RE: S92 Response – RMA20240068 147 Napier Road, Havelock North

I refer to your request for further information dated 4 April 2024 and our subsequent meeting of 16 April 2024. As set out below, all the information requested is provided in this response letter and the attachments to it. The numbering, subheadings, and information requested in your letter of 4 April 2024 are repeated below, followed by an explanation of the response provided on behalf of Sun Properties Limited.

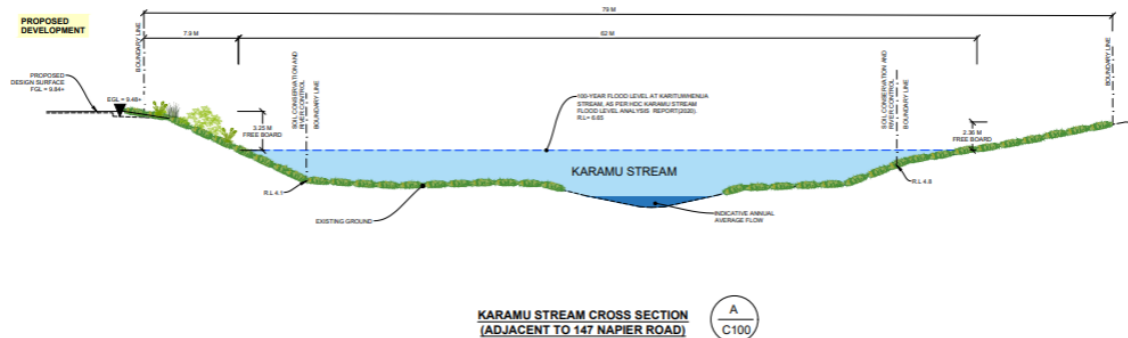
- 4. Please provide a cross-section of Karamu stream showing flood level in relation to the building platforms.*

Strata Group have prepared the following Karamu Stream cross section:

Please see the attached Strata Group Sheets C100 and C101 for the full-size plans of the above cross section and development site design surface plans.
